City of Tucson (COT) Design Review Board (DRB) Meeting October 7, 2022 Case # DRB-22-11 / SE-22-35 (T22SE00035) Proposed New TEP Cottonwood Substation 3210 & 3255 S Cottonwood Lane, Parcel#119-18-030A, R-1 (88%) & R-2 (only 12%) Zoning

Special Exception Request (Continued)

Re: TEP Cottonwood Substation DP22-0188, T22SE00035

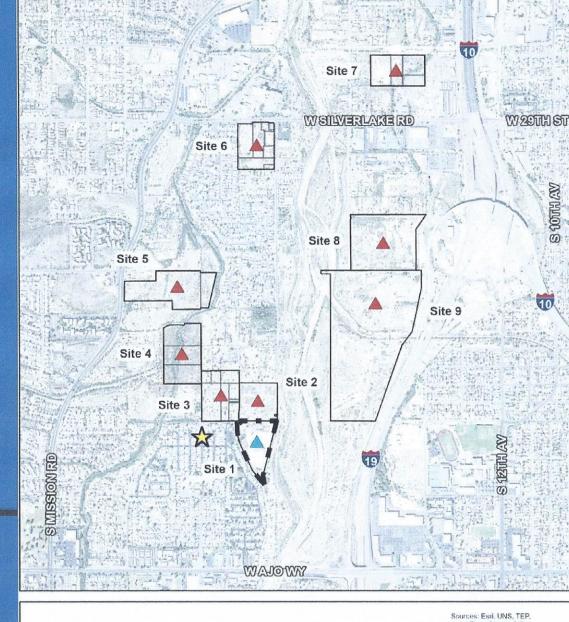
There were 8 other proposed sites not including the current temporary site at Ajo and Cottonwood Lane where bank protection already exists, Two of the 9 sites, 3 and 8 would have been more sensitive to residences and the environment, built on more stable ground and farther away from the banks of the Santa Cruz River. TEP bought

this R-1 zoned land that contains a mixed bag unstable fill next to the Santa Cruz River. TEP knew they would need a special exception to build their substation here. One of the reasons TEP chose this site, as stated at the neighborhood meeting (question #6) was it is, "the most cost-effective siting option."
